MANDATORY SERVICE BULLETIN

NUMBER: SB11-07
REVISION: 00
DATE: 07/01/2011

SUBJECT: Nose Gear Piston Tube Cap Replacement

KODIAK 100 Series Aircraft, Serial Numbers 100-0046 and 100-0052.

Figure 1-1 – View of the Nose Gear (with expanded view of nose gear piston tube cap)

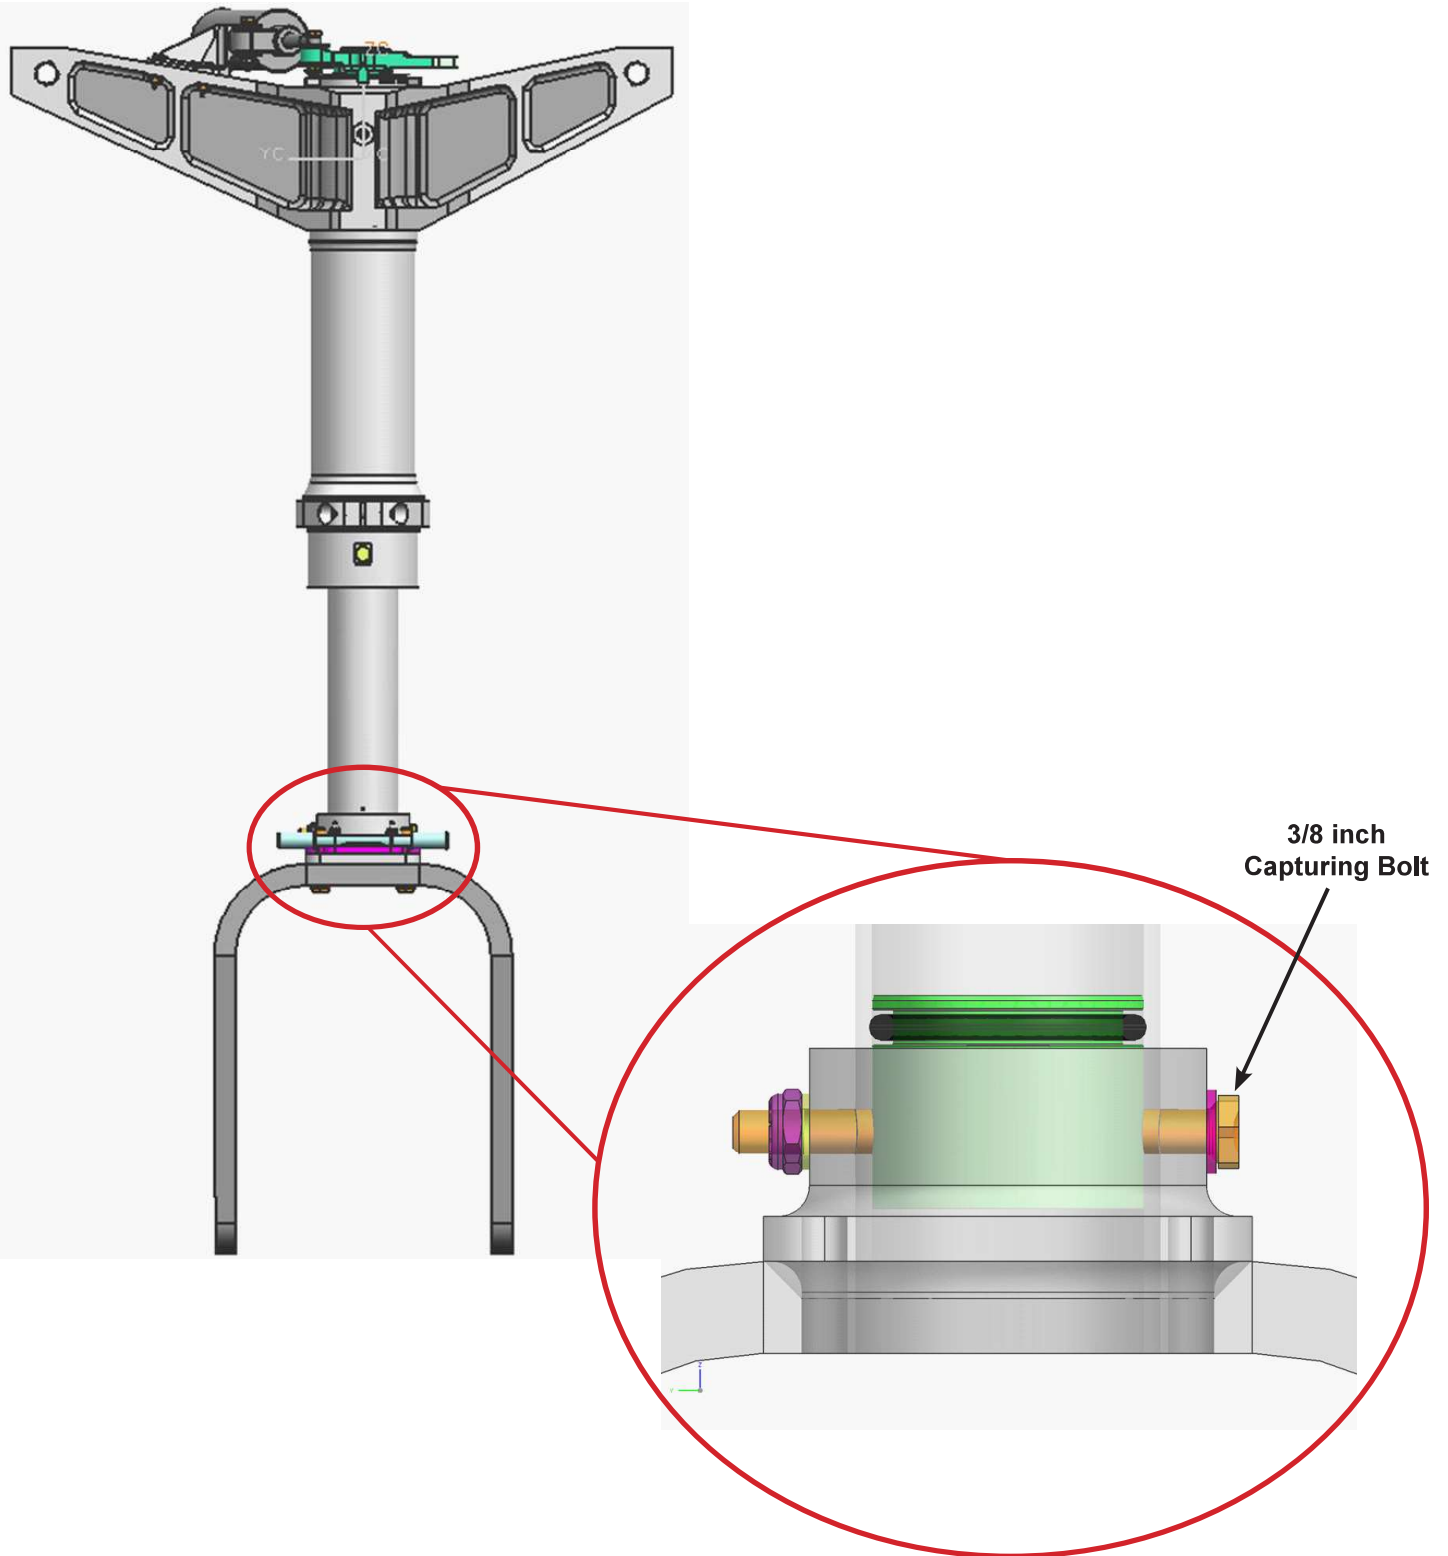
Quest has become aware of an issue with the nose gear piston tube cap (P/N **100-412-0103**) on certain airplanes. Our vendor inadvertently manufactured these parts from a different alloy of material than required in our approved design. We have investigated the effect of this deviation and have concluded in conjunction with FAA engineering that this does not affect the functionality or safety of the part. However, due to the parts not meeting the exact type design specifications, we are issuing a recall of the part. A new part will be provided by Quest, and should be used to replace the noncomplying part on your airplane.

Quest is mandating the replacement of the nose gear piston tube cap on the affected aircraft. Refer to the next part of this Service Bulletin for instructions on how to remove the old nose gear piston tube cap and install the new nose gear piston tube cap.

NOTE: *In the Figure above, the nose gear piston tube cap (P/N 100-412-0103) is shaded green, and the tow peg and fasteners are removed, for clarity.*

Figure 1-2 – Cross Section View Showing Pulling Pin in Place

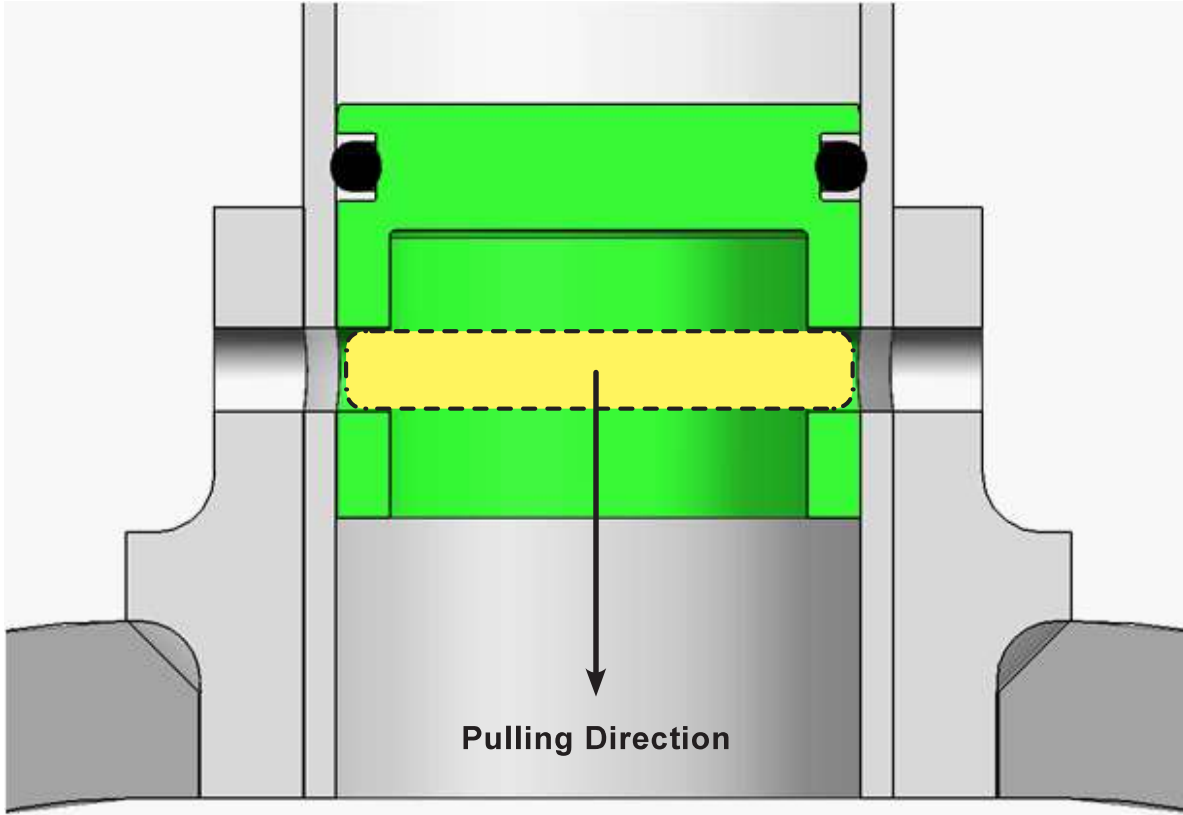
1. Suitably secure and jack the airplane so that the nose wheel can be removed (refer to **Chapter 7** of the *KODIAK 100 Airplane Maintenance Manual*).
2. Remove the nose wheel (refer to **Chapter 32** in the *Airplane Maintenance Manual*).
3. Bleed pressure off of the nose gear using the high pressure air valve.
4. Remove the capturing bolt from the nose gear piston tube cap (P/N **100-412-0103**). See **Figure 1-1**.
5. Install the shop aid (supplied with this Service Bulletin kit) through the 3/8" capturing bolt hole, as shown in **Figure 1-2**.

Figure 1-3 – Cross Section View Showing Clearance for Pulling Pin

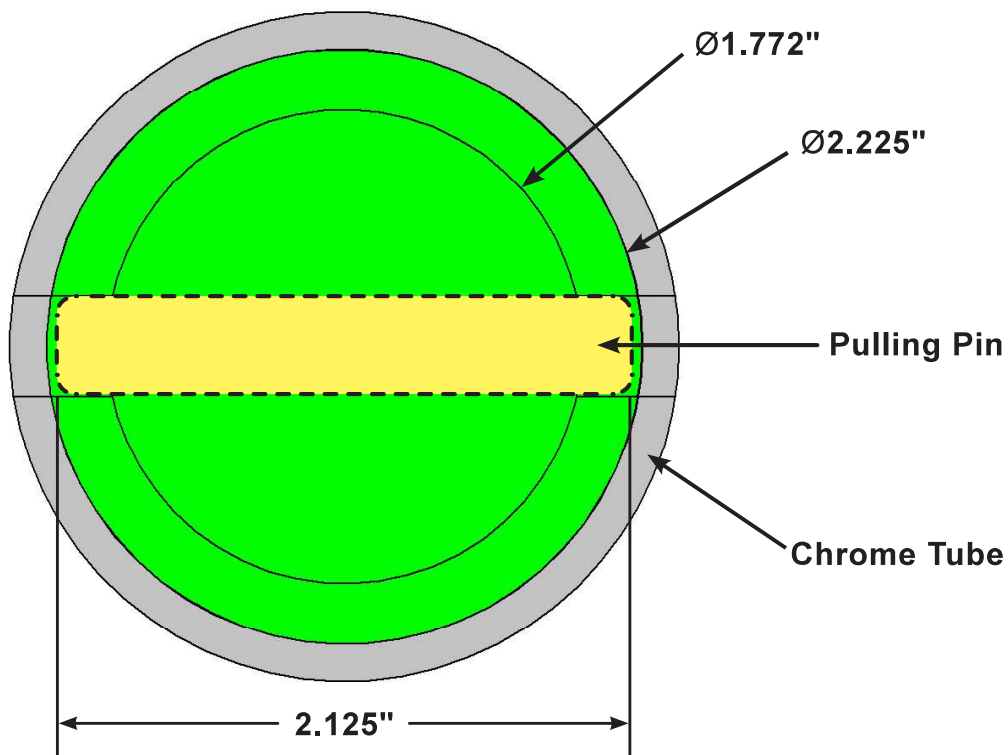
CAUTION: To avoid damaging the chrome tube, ensure that the shop aid is centered in the piston tube cap, as shown in **Figure 1-3**.

Figure 1-4 – Capturing Bolt Installed through the Hole in the New Tube Cap

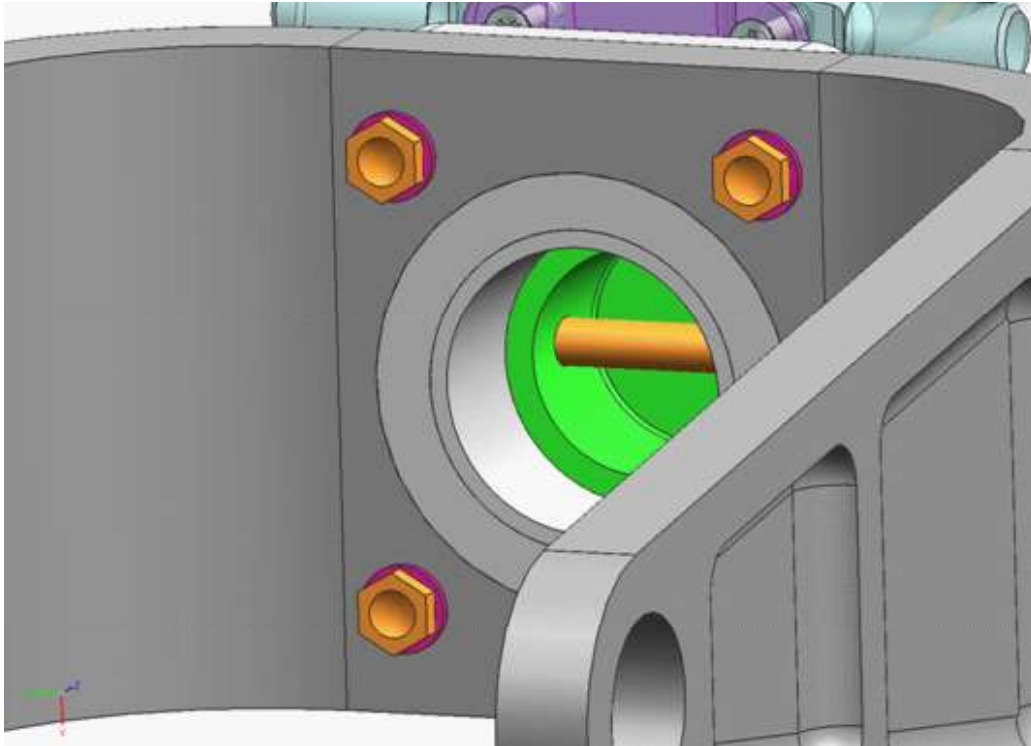
1. Ensure that there are no sharp edges where the 3/8" capturing bolt passes through the inside of the chrome piston tube. If sharp edges are found, deburr appropriately.
2. Install the new nose gear piston tube cap, using Parker lube (or equivalent) and the new supplied O-ring (P/N **M83461/1-328**).
3. Align the hole in the new tube cap with the capturing hole in the chrome tube, and install the 3/8" capturing bolt.
 - A. Looking up through the bottom of the nose gear, ensure that the capturing bolt passes through the capturing bolt hole in the new tube cap. See **Figure 1-4**.
4. Service the nose gear shock strut (refer to **Chapter 12** of the *Airplane Maintenance Manual*).
5. Reinstall the nose wheel.
